PLACER COUNTY PLANNING DEPARTMENT

PLANNING APPEALS

- 1. Project name Homewood Mountain Resort Ski Area Master Plan
2. Appellant(s) Friends of the West Shore, et al. (Attachment 1) 530-525-5452
Address P.O. Box 552
Telephone Number Homewood CA 96141
City State Zip Code

Re: Homewood Mountain Resort Ski Area Master Plan (California State
Clearinghouse #2008092008, Placer County Project Number PEIR T20080052
and TRPA Project Number STD20061130)

Figure 15-15. Off-Site EIP Project Design Schematic

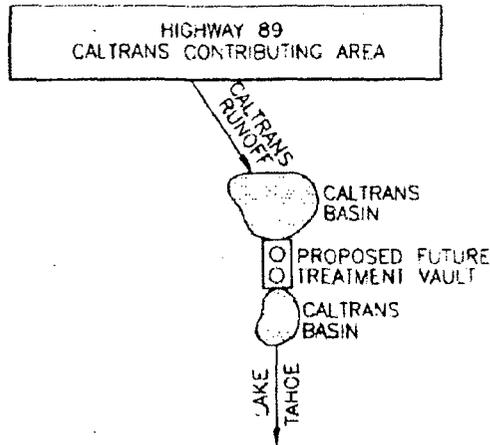
To increase the HMR-CEP effectiveness, consideration should be given in a revised DEIR to routing stormwater to an infiltration gallery after treatment by the Contechs system, in a fashion similar to the treatment train that is proposed for stormwater treatment for the project. Discharge to a basin, especially during high-flow conditions will not be as effective in reducing TSS.

Project No.: Homewood Ski Resort			
Title: 2005 Orthographic Imagery and 1970-1971 Detailed Site Investigations Map, North Parking Lot			
Project No.:	438	Drawn By:	JAC
Approved:	MH	Date:	04.13.2011
			Figure: 2

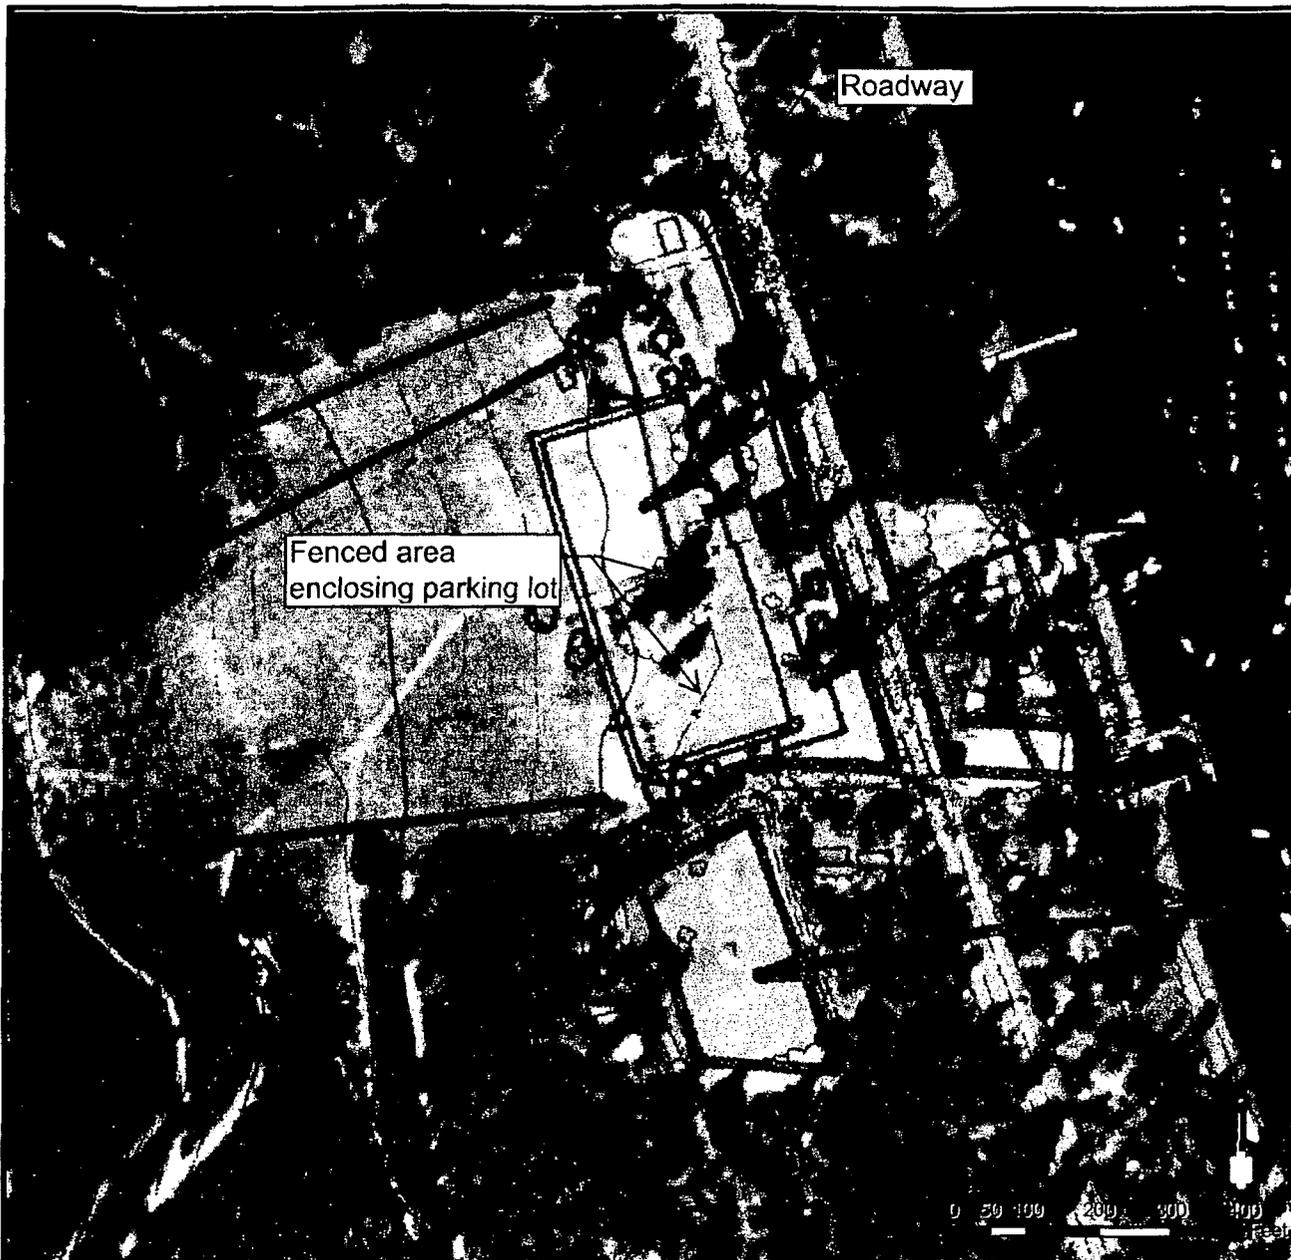
Additionally, we have conducted an analysis of the North Base parking lot and have determined that the majority of the parking lot was not in existence as of February 10, 1972. Figure 2 shows an overlay of a map prepared on the basis of conditions that existed as of November 1971 (Attachment 2), arguably the same conditions that would have existed on February 10, 1972 given that the winter season would have prevented any further development.

Figure 2 depicts two features that indicate the parking lot was not in existence in February 1972.

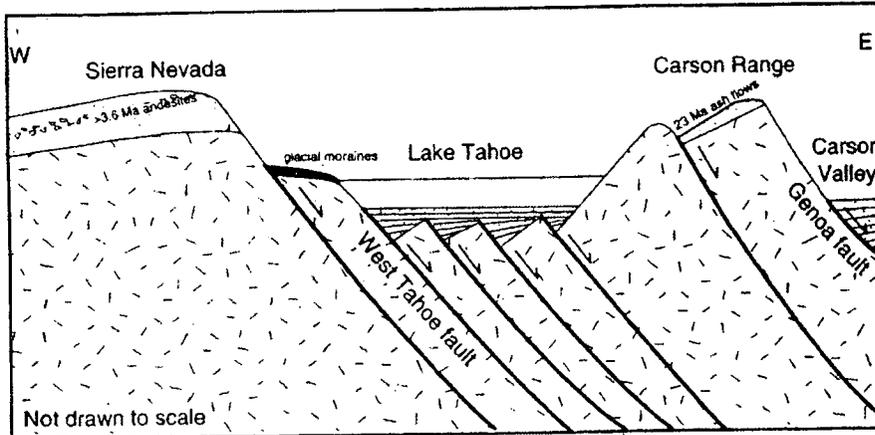
Lake Tahoe and the Tahoe Basin have been created by episodic, differential displacements across a suite of generally north-south trending faults (Figure 1). Although the faults were always suspected of being geologically young, it is really only in the past decade that research has begun to both confirm, and generate quantitative results on just how active they are. In essence, the paradigm of seismic hazards and vulnerability of the Tahoe Basin is in flux, and that hazard is definitely increasing. It is therefore unfortunate that the Homewood Resort's EIR relies on generally older references to the seismic hazards, sources which have mostly been superseded by more recent, and more technically advanced, studies. That the two geotechnical engineering reports do not provide this information either probably made the EIR preparer's task more difficult.

In my opinion, Unnamed Fault 1 is the west bounding fault system for the Tahoe Basin graben (Figure 1 and 4). It has a total length of at least 15 miles, it controls the location of Quail Lake (Figure 3), it ties directly into the known active fault through the lake (West Tahoe fault), it is identified as potentially active, and it has major hazard implications for the project that have never been quantitatively addressed.

Figure 2: Annotated geologic map of the western side of Lake Tahoe, labeled to show the primary fault systems, and a potential northward extension of the Unnamed Fault 1. Modified from Saucedo, 2005, and available at <http://www.quake.ca.gov/gmaps/RGM/tahoe/tahoe.html>

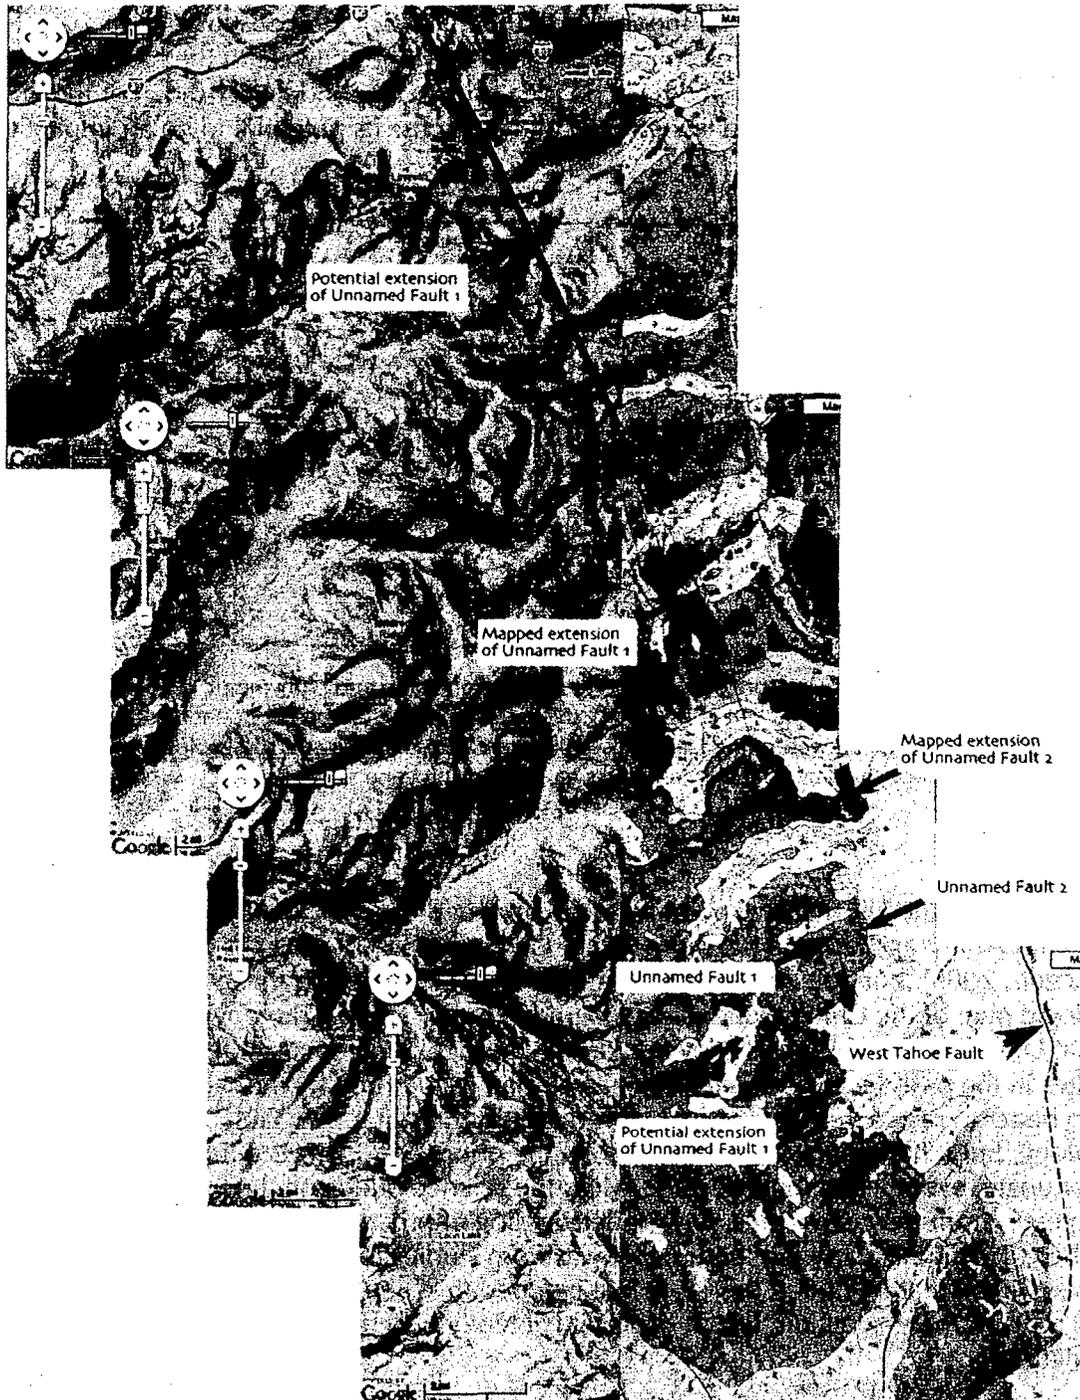
On Page 14-8, the EIR makes a point that the Unnamed Fault #1 (Figures 2 & 3) is shown as a Quaternary-age fault on the more recent Geologic Map of the Lake Tahoe Basin (Saucedo, 2005), but they make more of a point that the fault is not shown on the older geologic map of the Chico Quad (Saucedo and Wagner, 1992). The obvious interpretation is that Unnamed Fault 1 was discovered during the significant focus on Lake Tahoe seismic studies in the past decade. Indeed, the newer map is authored by the same geologist. Who better to revise their own work? This does not make it a new fault, it has been there all along, but it had not been mapped during the prior work. This is a frequent (though unfortunate) event in geology, because while the science builds on the past work, it progresses from new exposures, new understanding of processes, and new expertise being applied. In this case, I would note that it was from studies focused on the seismic hazards of Lake Tahoe that identified this fault, that mapped this fault, and that consider it to be at least a Quaternary-age fault, which makes it "potentially active" under California A-P regulations.

The EIR also states that the fault is short and discontinuous, making the hazard low for it to be big enough to be hazardous. This is neither accurate nor true. The Unnamed Fault 1 has been mapped at least another 5.5 miles north of the project site (to the limits of the Tahoe Basin mapping), and the geomorphology of the fault can be interpreted for at least 4.5 more miles past the map limits (Figure 2). Furthermore, the southern termination of the Unnamed Fault 1 can (and should) be interpreted as stepping to the west onto another unnamed fault system that continues an additional 5 miles southeast before joining with the West Tahoe Fault in Emerald Bay (Figure 2).

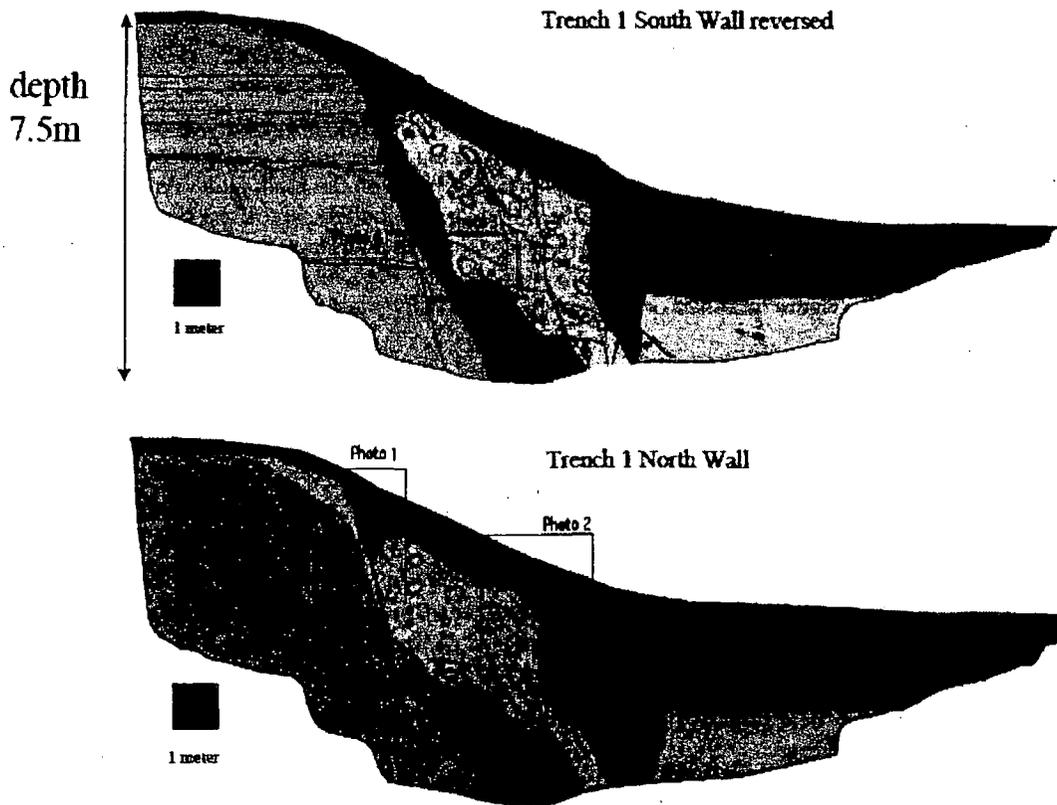
The only way to definitively confirm or refute a fault rupture hazard on these two potentially active faults is to conduct exploratory geologic trenching similar to that done for the Incline Village fault (Figure 6). The boreholes and test pits conducted for

geotechnical engineering and hydrogeological analysis are totally inadequate for active fault determination. The standard of practice for fault investigations requires that the fault actually be exposed in direct contact with sediments which are of a suitable age to show the timing of the last fault rupture. Selection of the trenching sites for such studies require a consideration of the fault's kinematics (anticipated sense of movement), the geologic conditions along the fault, the age of the sediments, and the hydrogeology. Since the state's A-P Act has defined an active fault as one which has displaced sediments of Holocene age (about the last 11,000 years), it is therefore necessary to expose the fault trace as overlain by sediments at least that old in order to conclude that the fault is not active. If the sediments are younger than 11,000 years, and are impacted (offset) by the fault, then the fault is considered active and structural setbacks from occupied buildings are required, and additional design impacts (especially infrastructure) should also be evaluated. If the faults are determined to be active, then additional trenching will be necessary to accurately track the fault locations across the site and to define an appropriate width for the setback zones; which may vary with fault zone complexity changes across the site.

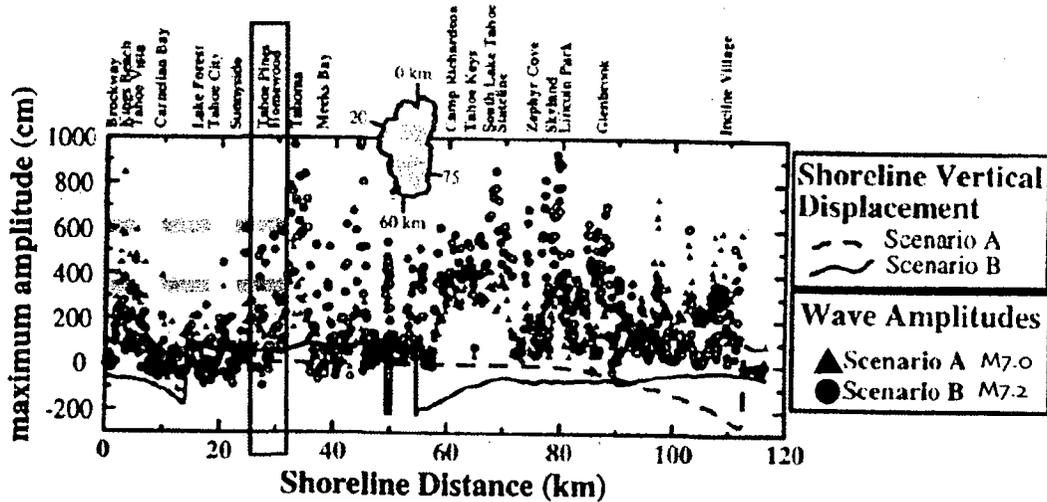
Ichinose et al. (2000) modeled the lake basin deformation from Mw 7.0-7.2 earthquakes on the Tahoe basin faults and estimated that tsunami wave amplitudes could be between 3 and 10 m, depending on the shoreline geometry around the lake. At the Homewood project site, they model a 3.5 to 6.0 meter wave height runup (Figure 7). While still

somewhat controversial, Gardner et al (2000) proposed that a large earthquake on the Tahoe basin faults triggered the McKinney Bay mega-slide [Schweickert et al. (2004) estimated a Holocene age for the event], and modeled that the landslide could have produced a tsunami wave more than 100 m in height.

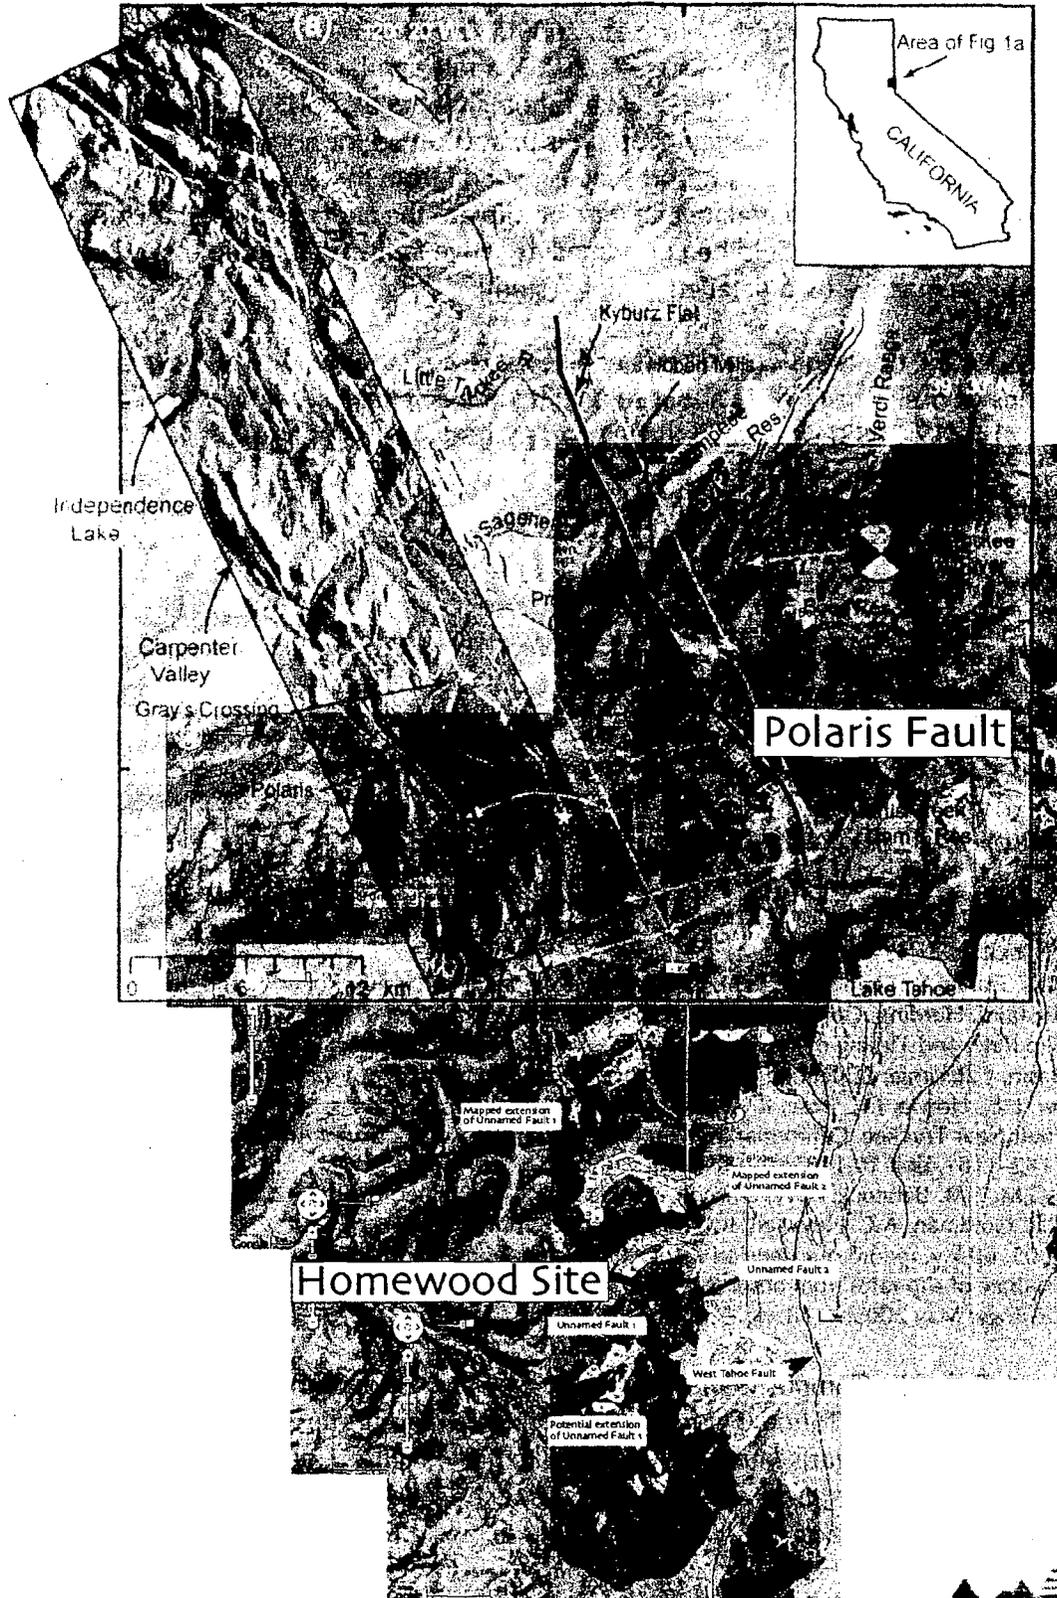
The Newly Discovered "Polaris Fault" and its Relationship to the Faults Through the Homewood Resort
